From: Mark Hudson <markhudson@growit.plus.com>
Sent: 31 January 2015 11:36
To: Shinkin, Craig
Subject: Re: Ash court
Attachments: CBR info.doc

From: Mark Hudson [mailto:markhudson@growit.plus.com]
Sent: 01 December 2014 19:00
To: Shinkin, Craig
Subject: Ash court

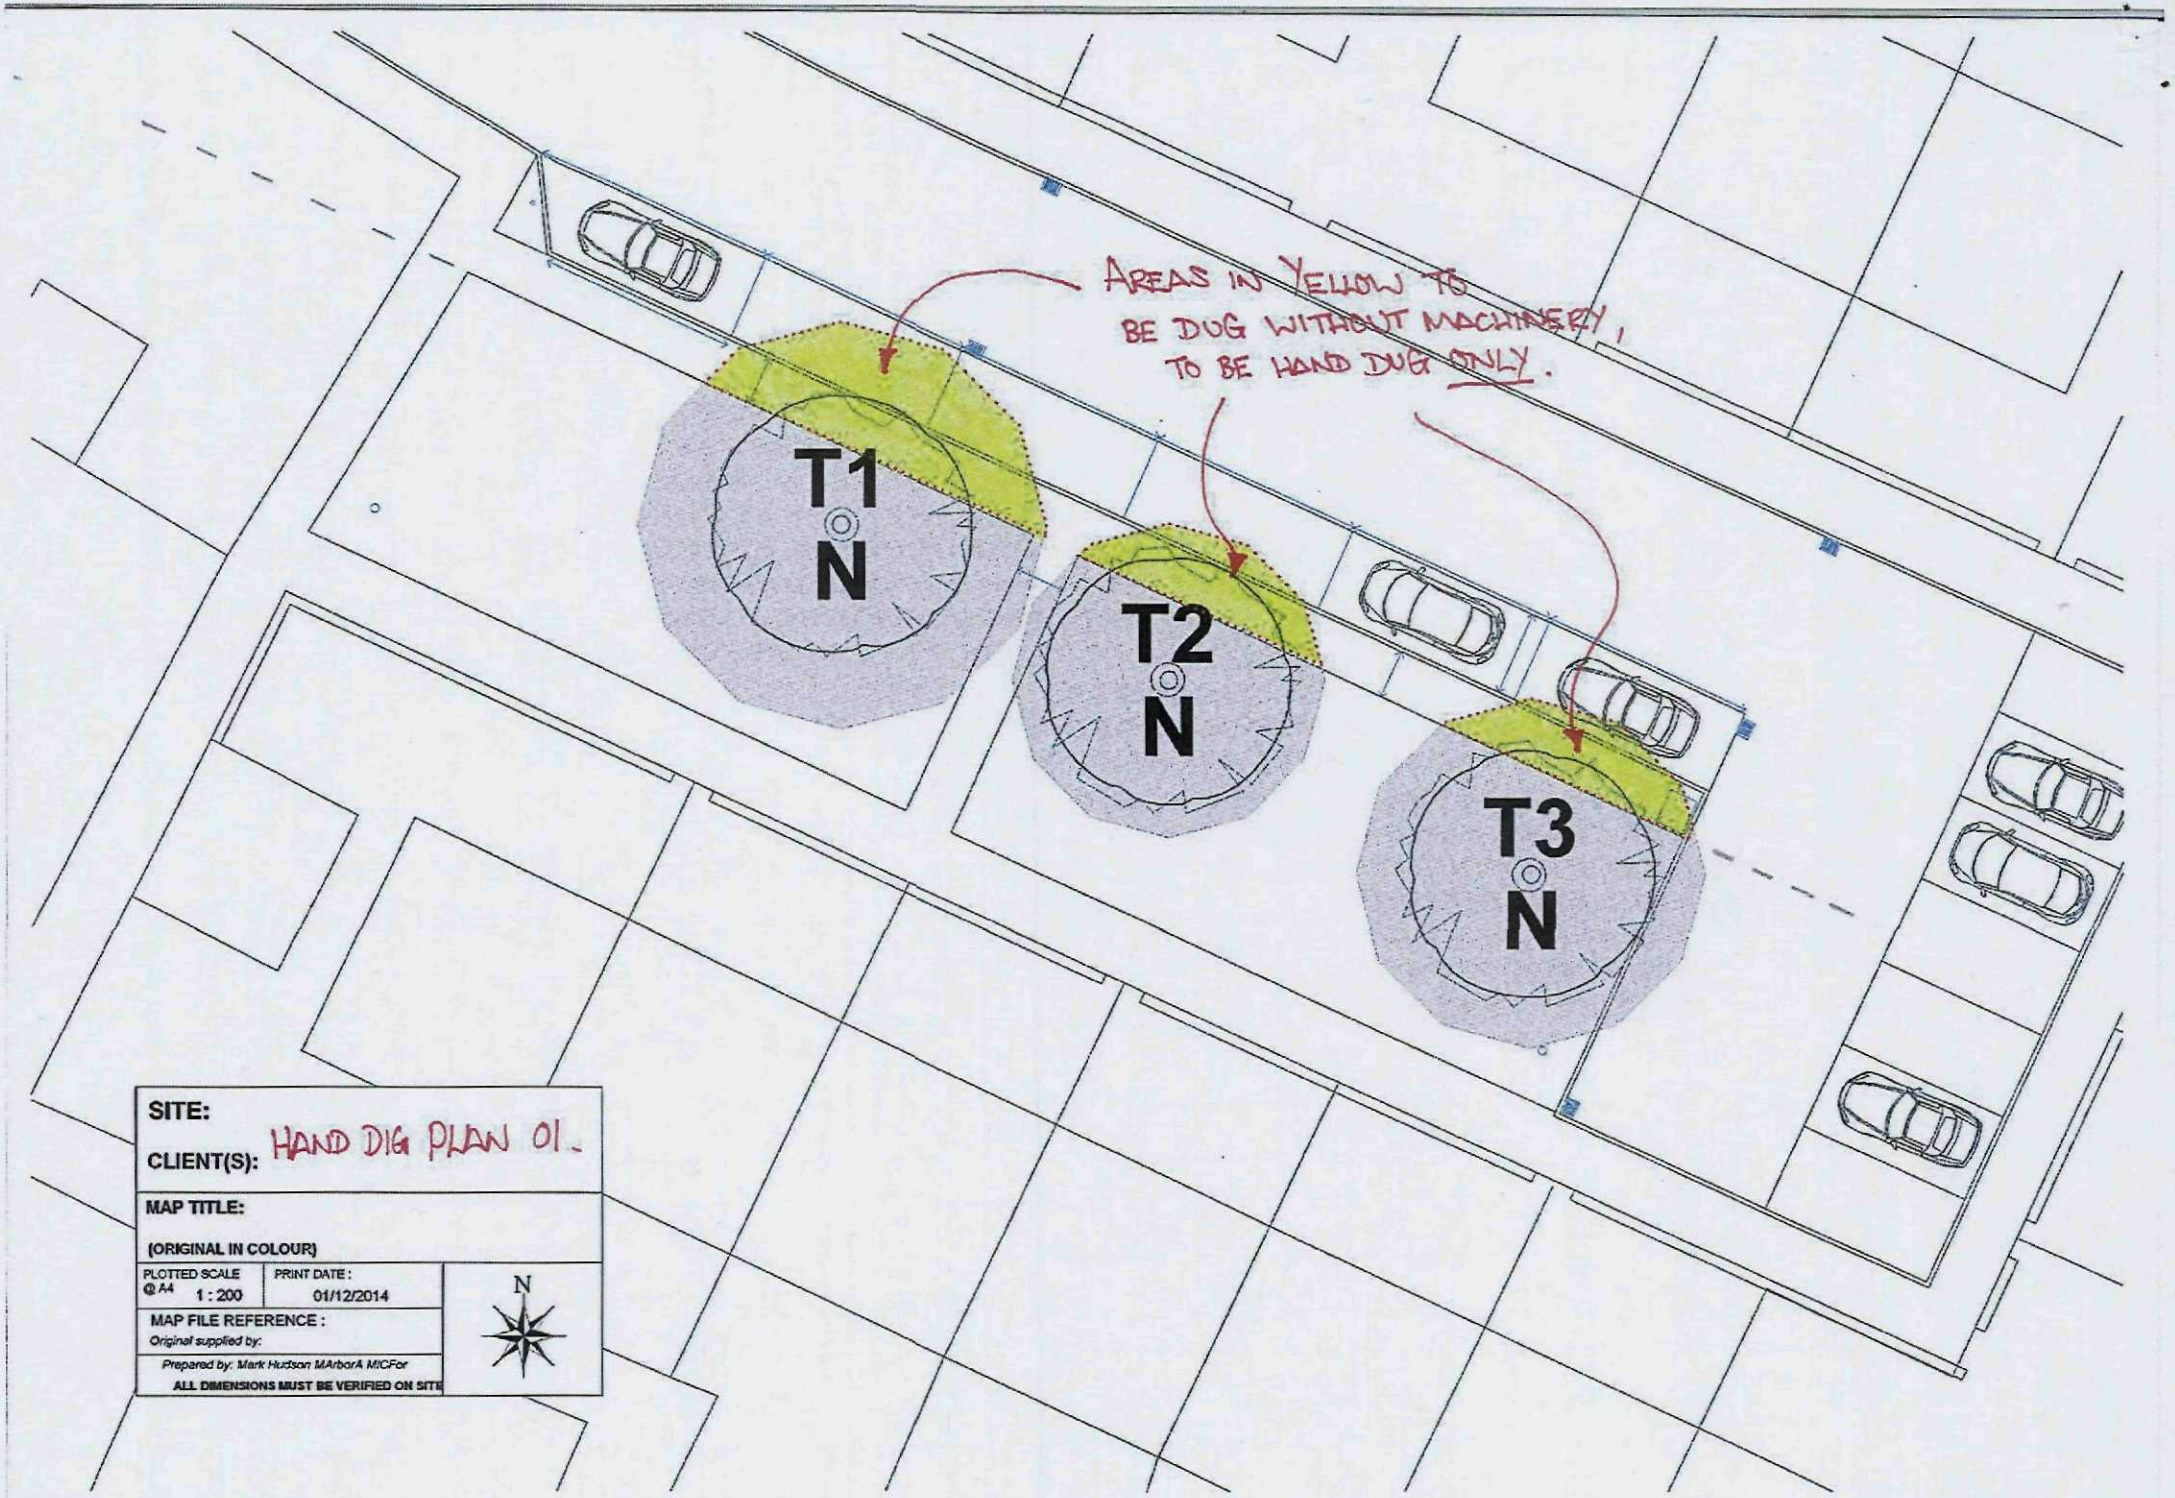
red hatched area represents the recommended root protection area (RPA), red dotted area the area of disturbance

by measuring on my mapping software I suggest the relevant % of disturbed area are:

T1 (Red tree) - 18%
T2 (Yellow tree) 12%
T3 (Blue tree) 10%

Research suggests that trees of normal vigour may root stand loss of up to 20% without significant effect

My recommendation is, use a cellular confinement system (see www.geosyn.co.uk) to 100mm depth in parking areas (this is suitable for cars and light vans - engineer to confirm), 75mm for pedestrian paths, surface with porous flexipave or similar (see sudscape treescape also - you will find it by internet search) - do all works to lower levels within tree RPA's by hand, and the team probably won't even discturb the percentages shown above

Kerbs can be set in to the cell conf system but shield roots from concrete with polythene
